WARRENTON PLANNING COMMISSION
Regular Meeting | January 12, 2023 | 6:00pm
Warrenton City Hall Commission Chambers | 225 S Main Avenue, Warrenton, OR 97146

- A. Continuation: L&D Race Tech Motorcycle Shop Site Design Review (SDR-22-2) on tax map 81022DD, Lots 06100, 06200, 06300, 06500, & 06501

TO: The Warrenton Planning Commission
FROM: Jay Blake, Planning Director
DATE: January 10, 2023
SUBJ: Site Design Review for L&D Race Tech, Inc. on Parcels in Section 22 of the City of Warrenton, Parcels #81022DD6100, 6200, 6300, 6500, and 6501

SHEET NUMBER
C400

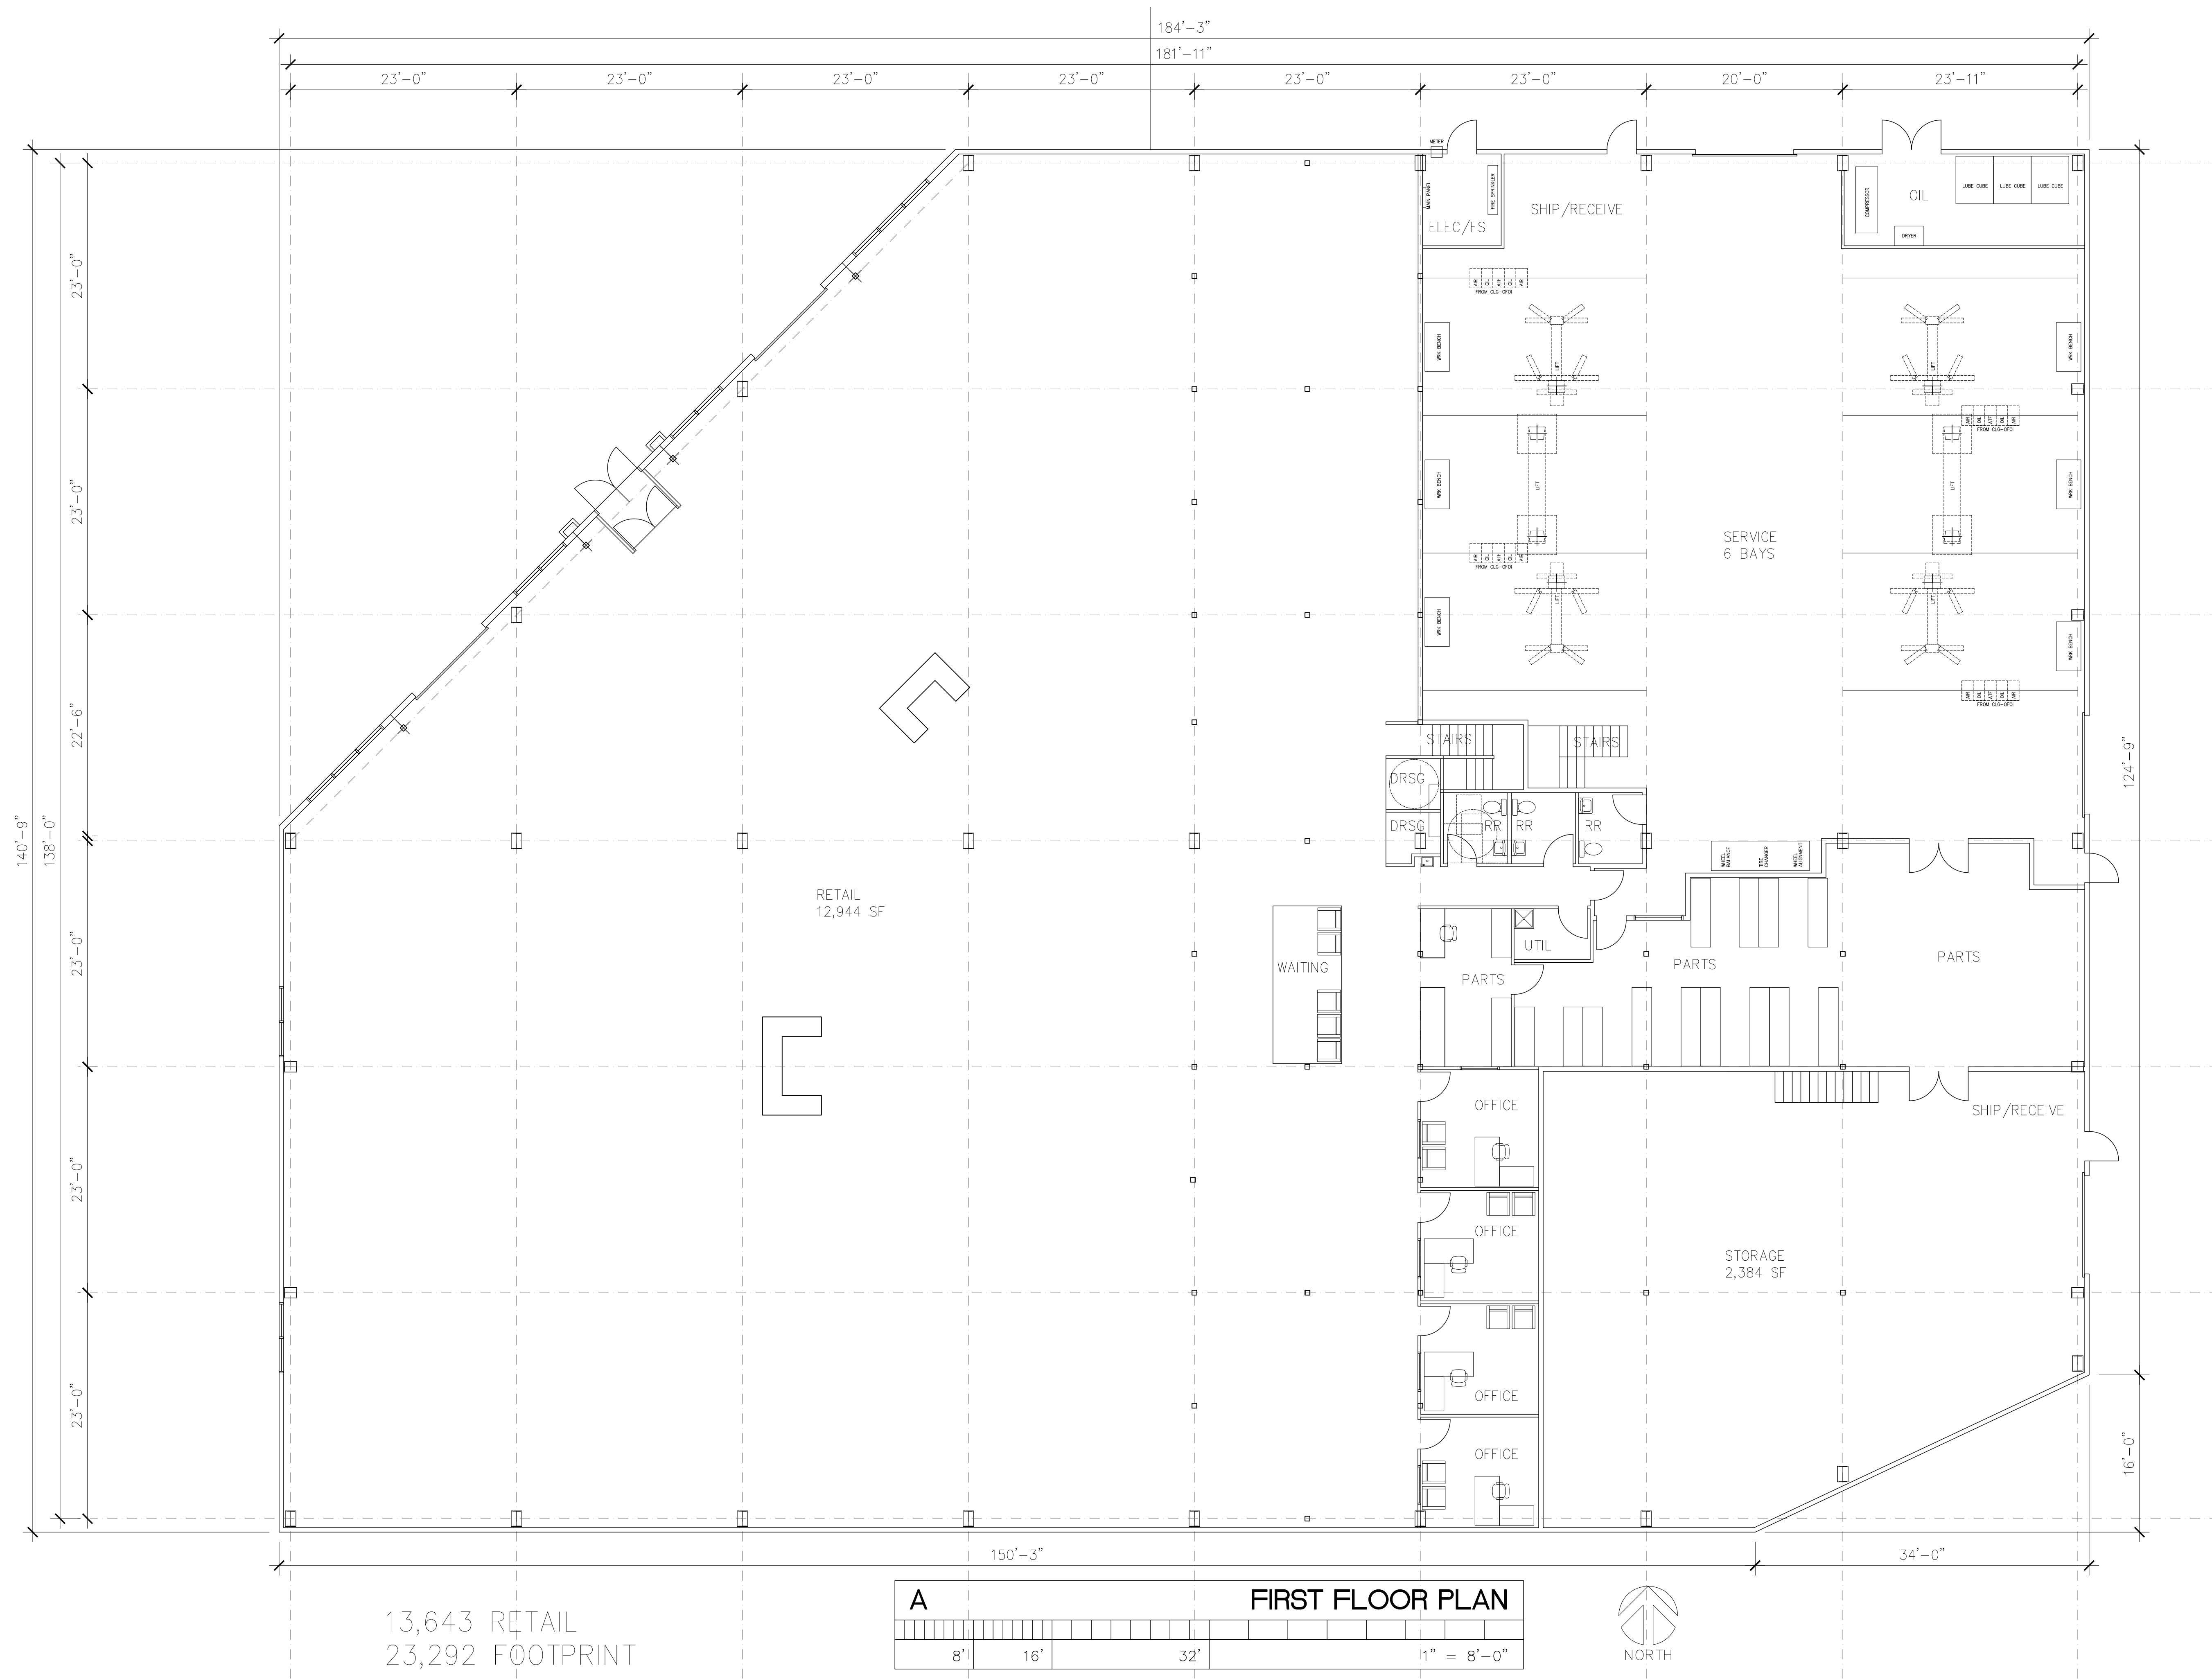
17. A landscape plan was submitted. The plan states that a "Proposed Lawn/Ground Cover" will be used. More detail should be provided prior to the issuance of the building permit. The plan includes the installation of thirteen (13) Street trees along SE Marlin and SE 10th Street. Species are not noted. They should be non-invasive hearty trees for our zone.

18. Twenty-five percent (25%) of the site is reserved for landscaping. No landscaping is proposed adjacent to the structure.
19. Fence height is limited to six (6) feet unless a variance is granted by the Planning Commission.

4. The applicant shall supply a more detailed landscape plan that meets the requirements of WMC 16.124 to be reviewed by the Planning Director prior to the issuance of the Building Permit.
